Docket No. PROJ 0782

KHNP Response to RAI 3-7443 on Topical Report
“KCE-1 Critical Heat Flux Correlation for PLUS7 Thermal Design”
APR1400-F-C-TR-12002-P, Rev. 0

RESPONSES TO REQUEST FOR ADDITIONAL INFORMATION 3-7443

Figure 2-1 Typical Example of Characteristic Temperature Decay

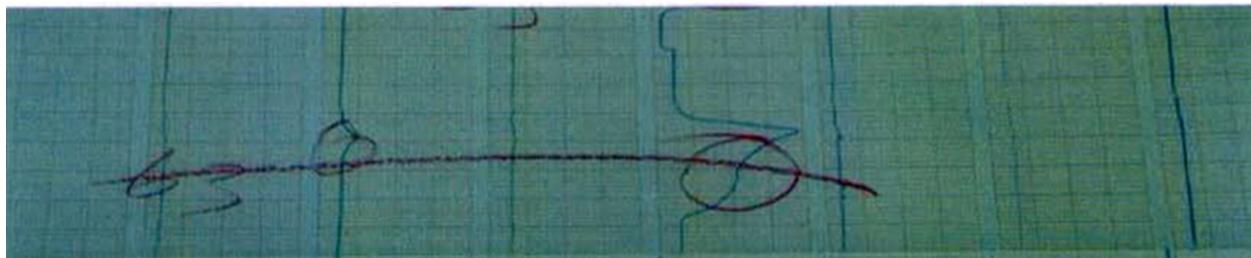
The topical report described that the CHF point was confirmed when increasing the total power led to a temperature excursion of 10 to 30°F inside the heater rods. When the temperature indication was minimal, confirmation of the validity of a CHF point was obtained by observing a characteristic temperature decay with power reduction, as the CHF zone was rewetted. The applicant is asked to justify the above-mentioned CHF point confirmation technique, possibly by including a citation in the report that corroborates it.

The CHF identification criteria described in Topical Report (APR1400-F-C-TR-12002-P) have been used and accepted in past application as described since early phase of HTRF operation (Ref. EPRI-NP 2609 vol. 1, Sep. 1982). Typical shape of characteristic temperature decay can be identified in Figure 2-1 (biggest red circle in right-side, but temperature excursion of this case is sufficient: time flows from top to bottom of the plot). This is due to the retarded recovery of heat transfer after CHF occurred ($D \Rightarrow D'$) from post-dryout film boiling to transition boiling ($D' \Rightarrow E \Rightarrow D$) or subcooled boiling ($D' \Rightarrow E \Rightarrow E'$), similar to hysteresis, inferred from typical boiling curve as shown in Figure 2-2 and heat transfer mechanism in corresponding boiling regime.

Figure 3-1 As-measured CHF elevations for PLUS7 CHF test

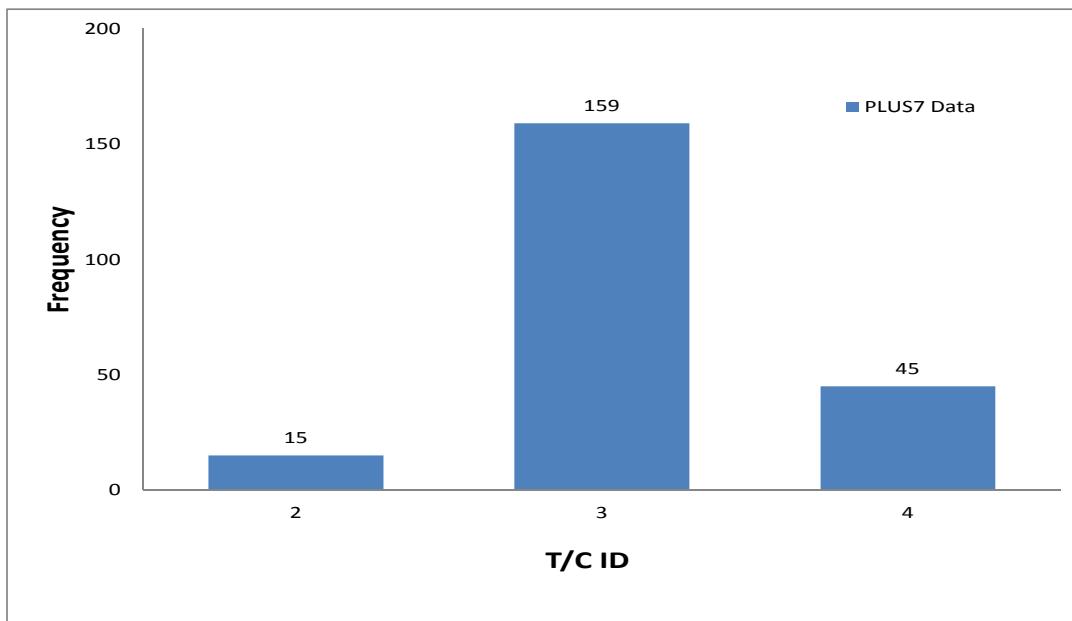
Figure 2-9 depicts seven thermocouples installed axially to measure the wall temperature of the heater rods. However, the thermocouple grid is asymmetrical between the BOHL (Beginning of Heated Length) and EOHL (End of Heated Length). Justify the temperature measurements made by using the asymmetrical thermocouples grid to be conservative with reference to the overall data reduction to compute CHF.

With axially non-uniform axial power distribution, the locations of CHF indication are the downstream of peak power for the test section with uniformly arranged spacer grids. The spacer grids of PLUS7 CHF test section were uniformly arranged except the upstream grid from EOHL.

For the cosine power distribution (peak at middle of heated length and symmetry) applied to PLUS7 CHF test (as given in Figure 2-8 of topical report), possible location of CHF would be thermocouple (T/C) ID of 1 through 5.

According to the actual test data for PLUS7, the CHF elevations are limited to T/C ID of 2 through 5 as given in Appendix A-1 of topical report (column of 'TC' with format of XX.x, where XX: rod identification number per Figures 2-5 to and 2-7 and x : T/C identification number per Figure 2-9 of topical report) and summarized in Figure 3-1. No CHF was indicated at the other location including BOHL and EOHL.

Therefore, no impact on CHF measurement and data reduction due to axial T/C configuration is applied to PLUS7 CHF test.
